Service Bulletin

Bulletin No.: PI0657A

Subject: Deformed or Dimpled Liftgate Center Applique, Liftgate Paint Damage Evident at Lower Outer Edge of Applique

Models: 2007-2013 Chevrolet Suburban, Tahoe
2007-2013 GMC Yukon Models, Yukon XL Models

2748947

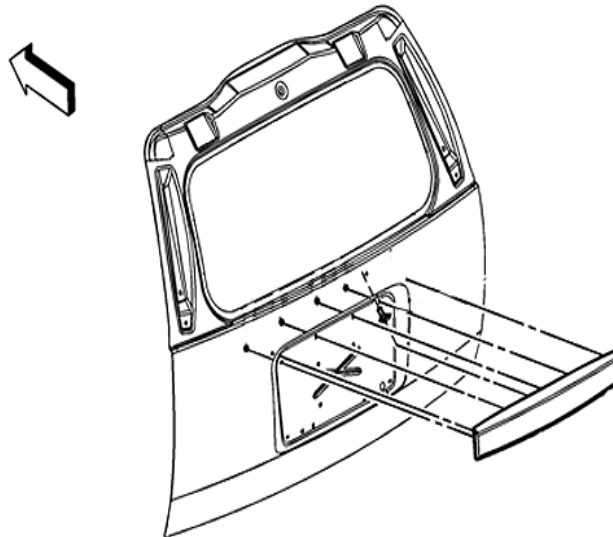
Some customers may comment on paint damage (shown circled above) on the liftgate at the lower outboard edges of the center applique.

The design of the applique in conjunction with the forming of the license plate pocket in the liftgate may allow the lower outboard edges of the applique to have contact with the liftgate.

The liftgate center applique design has been revised to be more resistant to overtightening, provide enhanced anti-rotation measures for the mounting studs and also provide an improved interface to lessen contact with the liftgate.

2748948

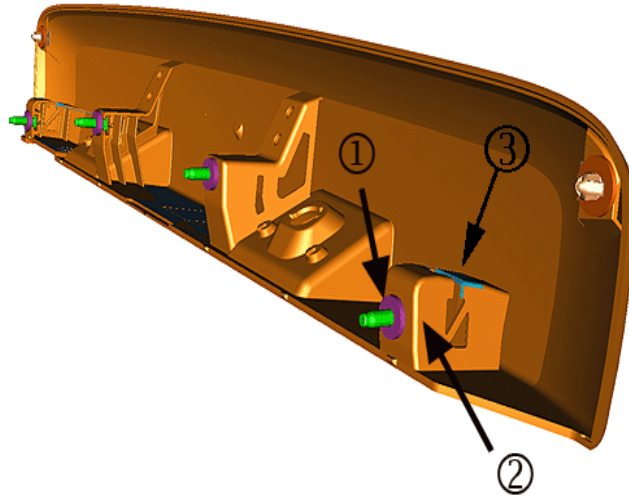
Note: The updated applique design went into production for the 2012 model year. The applique should **Not** require replacement on a 2012 or newer vehicle, unless Condition 1 is present.

For 2011 or earlier vehicles, replace the liftgate center applique with the appropriate new service part listed in the table below. Refer to Liftgate Center Applique Replacement in SI.

Note: P/N 15911310 is a 0.25 mm thick Mylar washer. The recommended guideline is to use four washers at each of the applique mounting stud locations, positioned over the stud, behind the foam washer, to achieve an additional 1 mm of gap between the lower edge of the applique and liftgate.

Tip: To correct Condition 2, the updated design applique is necessary, identified by a split along the top of the outer mounting boss locations (3). The updated design applique is already present on 2012 and new vehicles.

Additional clearance will need to be created between the lower edge of the updated applique design (3) and the liftgate. Add GM washer P/N 15911310 to the applique between the foam washer (1) and the mounting boss (2) at each of the four mounting stud locations. Stack the washers to obtain the needed amount of spacing along the lower edge of the applique to prevent contact to the liftgate, while providing a good appearance.
